Product hierarchy no. *			archy no. *	Part no.	SBU	Type / Description	Customer part no.
SBU F	PG	PUG	Туре				
)	0000000531		Circuit protection	Fuseholder OGD	n/a

2 Type of change

Product CI	hange Notifi	cation		Inscription change OGD				
owner	creation date	release date	released by	change order no	rev	page	D10-012-849	
dislercy	2017-01-23	2017-02-22	nowakfr	2011942	Α	1 of 1

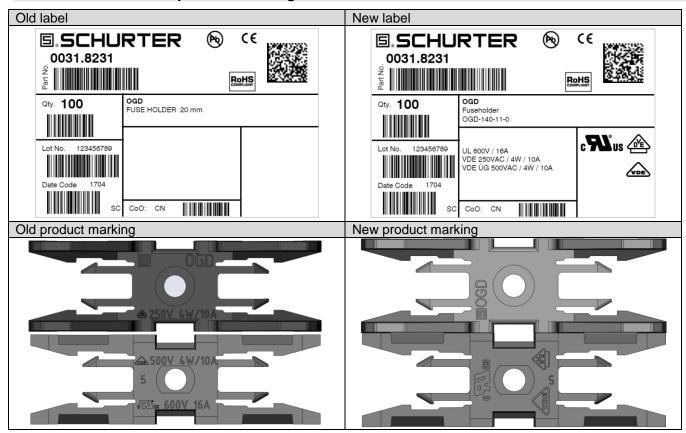
- Modified label
- Change of markings

Adjusted product markings acc. to current standard and approvals.

Form Yes Inscription on socket changed
Fit No No change for dimension
Function No No functional change

Label Yes Approvals and configuration code on label
